Access Compliance Report

Public Rights-of-Way

(Curb Ramps)

Intersection ID: 11232	Main Street: BARRINGTON_DR	Cross Street: MILTON_RD	Location: NE
ADA ID: B71181D9D7EE	Ramp Type: PerpDiag	Initial Pass/Fail: Fail	Overall Compliance: No
Codes/Mitigation Info/Possible Solution		Field Measurements/Component Compliance	
Severity Score: 21.25

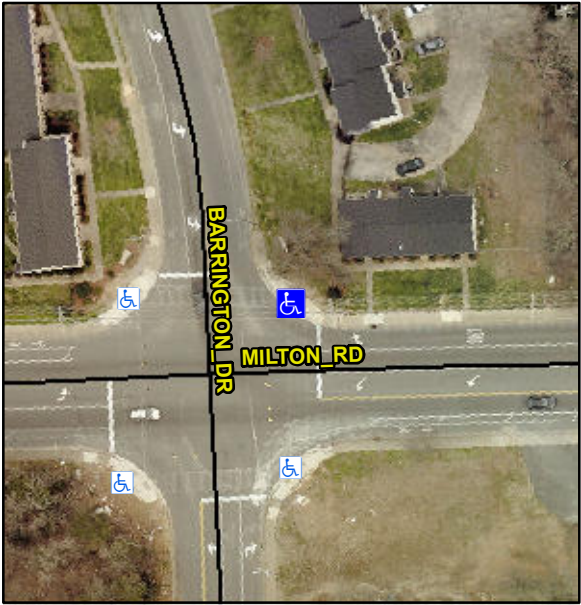
Possible Solutions:		Compliance	Description	Data	Compliance	Description	Data
	Remove & Replace Curb Ramp With Two New Directional Ramps or Equivalent.		N/A	Ramp Length (in)	60.0	No	Ramp Slope (%)	11.5
<p>Surveyor Notes:</p> <p>N/A</p> <p>PROW/ADA:</p> <p>Not Found, R304.5.1, R304.2.2</p>			No	Ramp Width (in)	41.5	Yes	Ramp XSlope (%)	0.5
			N/A	Flare Type LT	N/A	N/A	Flare Type RT	N/A
			N/A	Flare Slope LT (%)	N/A	N/A	Flare Slope RT (%)	N/A
			N/A	Flare Traversable LT?	N/A	N/A	Flare Traversable RT?	N/A
			N/A	Landing Length (in)	N/A	N/A	DWS Provided?	N/A
			N/A	Landing Width (in)	N/A	N/A	DWS Contrast?	N/A
			N/A	Landing Slope (%)	N/A	N/A	DWS Length (in)	N/A
			N/A	Landing X Slope (%)	N/A	N/A	DWS Full Width?	N/A
			N/A	Landing Curb? (Y/N)	N/A	N/A	DWS Offset (in)	N/A
			N/A	Shared Landing?	N/A			
			N/A	Gutter Ponding?	N/A	N/A	Gutter Slope (%)	N/A
			N/A	Gutter Lip Ht (in)	N/A	N/A	Gutter X Slope (%)	N/A
			N/A	Painted X Walk1?	No	N/A	Painted X Walk2?	No

X Walk 1 Direction	To W		X Walk 2 Direction	To S
			N/A	X Walk 1 Width (in)	N/A	N/A	X Walk 2 Width (in)	N/A
				X Walk 1 Slope (%)	0.4		X Walk 2 Slope (%)	2.8
				X Walk 1 X Slope (%)	0.4		X Walk 2 X Slope (%)	0.8
			N/A	Ramp inside XWalk1?	N/A	N/A	Ramp inside XWalk2?	N/A
				Road Slope (%)	1.0	N/A	Clear Space?	N/A
				Road X Slope (%)	2.6	N/A	Clear Space to XWalk (in)	N/A
			N/A	Any Obstructions?	N/A	N/A	Storm Grate/Utility Hazard?	N/A
				Obstruction Type			Storm Grate/Utility Type	
						N/A		N/A
						Yes	Surface Condition? (G/P)	Good
